13 December 2022

SECTION 4.55(1A) MODIFICATION APPLICATION – SSD 6965 BUILDING R4B, ONE SYDNEY HARBOUR, BARANGAROO SOUTH

Figure 2 Proposed introduction of building identification signage

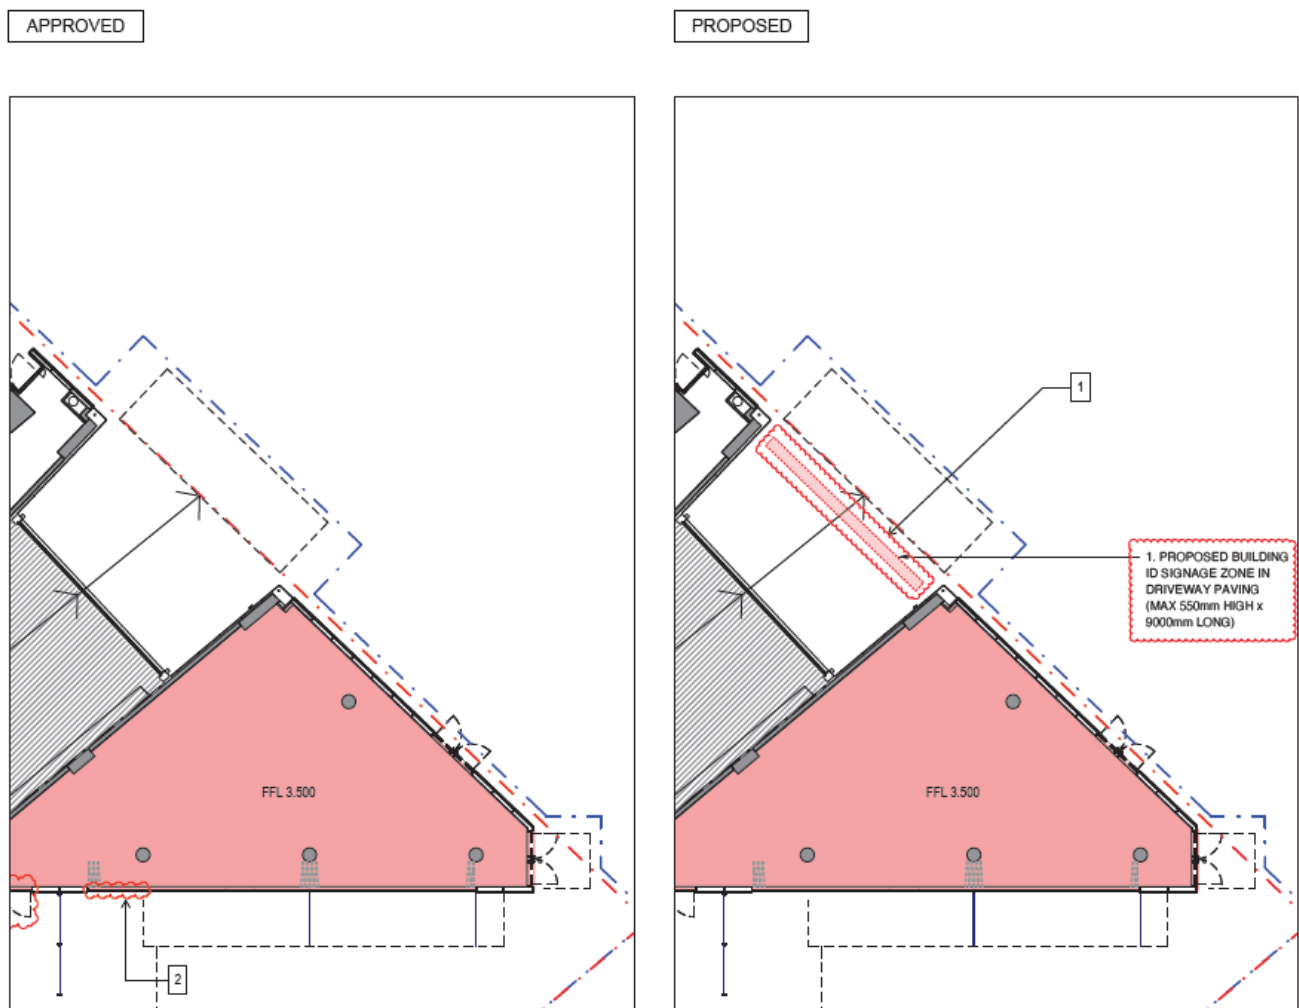
A new building identification signage zone is proposed to be located within the ground at the basement parking entrance ramp on the southern frontage of Building R4B. This signage is proposed to comprise of recessed metal lettering within the stone paving of the driveway comprising the words 'One Sydney Harbour', and will assist in wayfinding for visitors and residents of the three buildings.

This is shown in **Figure 2**. A reference image is shown at **Figure 3**.
